APPLICATION FOR SOIL INVESTIGATION

4) LOCATION OF PROPERTY Off Providence Road (8239 Houston Ridge Road
(STREET OR COUNTY ROAD)

5) SUBDIVISION Providence West LOT NO. 8 BLOCK NO. 3

SITE EVALUATION

**See Diagram on Back (includes: soil areas, property lines, roads, streams, gullies, wet areas, fill areas, wells, water bodies, slopes)

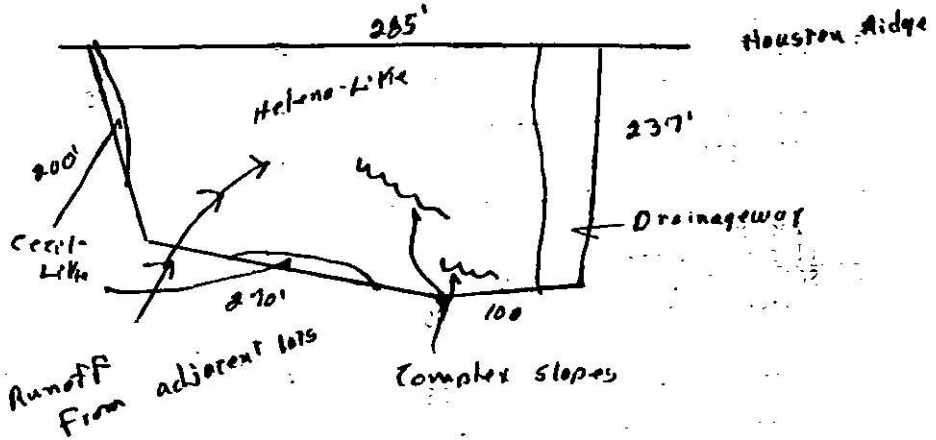
At your request, a field investigation was conducted on the property designated above and was classified unsuitable for the installation of a ground absorption sewage disposal system. A copy of the site evaluation report is enclosed for your information.

FACTORS	AREA 1	AREA 2	AREA 3	AREA 4
1. SLOPE (%)	S PS U 8-15%	S PS U 8-15%	S PS U complex slopes	S PS U —
2. SOIL TEXTURE (12-36 inches) Sandy, Loamy, Clayey (Note 2-1 Clay)	S PS U Clay	S PS U 2-1 Clay	S PS U —	S PS U —
3. SOIL STRUCTURE (12-36 inches)	S PS U Blocky	S PS U Blocky	S PS U —	S PS U —
4. SOIL DEPTH (inches)	S PS U 30-40"	S PS U 30-40"	S PS U —	S PS U —
5. RESTRICTIVE HORIZONS (Inches) (Impervious strata, Rock)	S PS U >36"	S PS U >30"	S PS U —	S PS U —
6. SOIL DRAINAGE/GROUNDWATER (external and internal)	S PS U >36" To ground water	S PS U perched water table 18-24"	S PS U Eroded Areas channel runoff	S PS U Drainageway
7. OTHER (Specify)	S PS U Restricted Area	S PS U	S PS U	S PS U
8. SOIL GROUP	IVA	IVB	—	—
9. SITE CLASSIFICATION	unsuitable	unsuitable	unsuitable	unsuitable
10. SOIL SERIES	Cecil-Like	Helena-Like	complex slopes	Drainageway
